The Bluewater Valley Downstream Alliance (BVDA), a core member of the Multicultural Alliance for a Safe Environment (MASE), hereby submits the following comments regarding a proposed amendment to the radon monitoring program at the Homestake-Barrick Gold Uranium Mill Tailings site north of Milan, New Mexico. The proposed amendment was brought to BVDA/MASE attention via a letter from the NRC. No one from the NRC offered to meet with members of our community or offered to explain what this proposed change might mean for our community members, who have been living over 40 years now with radon in the ambient air that, according to a recent USEPA Human Health and Risk Assessment draft report, is five times the EPA limit and represents 18 times the EPA's acceptable lifetime cancer risk standards.

For the reasons given below, BVDA requests the NRC staff deny Homestake-Barrick Gold's (H-BG) application to change the location of its background radon monitor.

Figure 4-1 Predicted transport of on-site sources of radon normalized to HMC-4 and HMC-5 average

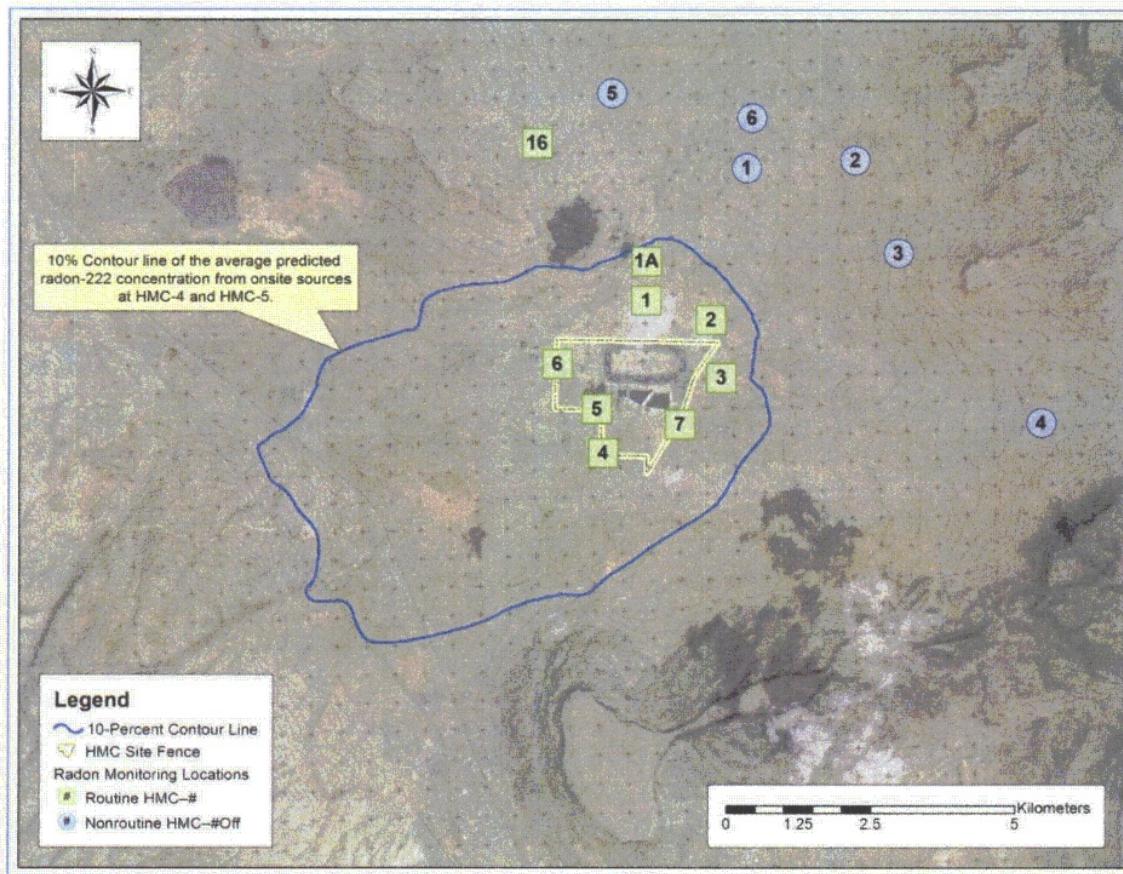
The amendment proposes to change the radon monitoring array used at the Homestake tailings site by replacing the radon monitoring site used as the baseline data source for NRC license purposes for more than two decades, named HMC-16, located about 3 miles north-northwest of the tailings, with a radon monitoring site located about 2 miles east of HMC-16 (“16” in “green square”) and about 2 miles north-northeast of the large tailings pile, named HMC-1Off (“1” in “blue circle”) as shown in the figure below.

In brief, H-BG’s Analysis supporting this proposed change asserts that HMC-16 may “underestimate background” and HMC-1Off would not.

Table 4.2 of the HMC consultants' report shows that Rn levels at location HMC-10ff are as high as ambient levels at the two monitors closest to the community -- HMC-4 and HMC-5 -- which, historically, have had the highest levels and therefore demonstrate substantial lung exposure risks to the people living closest to the large tailings pile. The consultants' report presents no data on soil uranium or radon levels at the HMC-10ff location. Wind rose patterns in the consultants' report, presented previously by Homestake-Barrick Gold, clearly show that the 10ff site would be in the direction of the most frequent winds, on the order of 8% to 10% of the time.
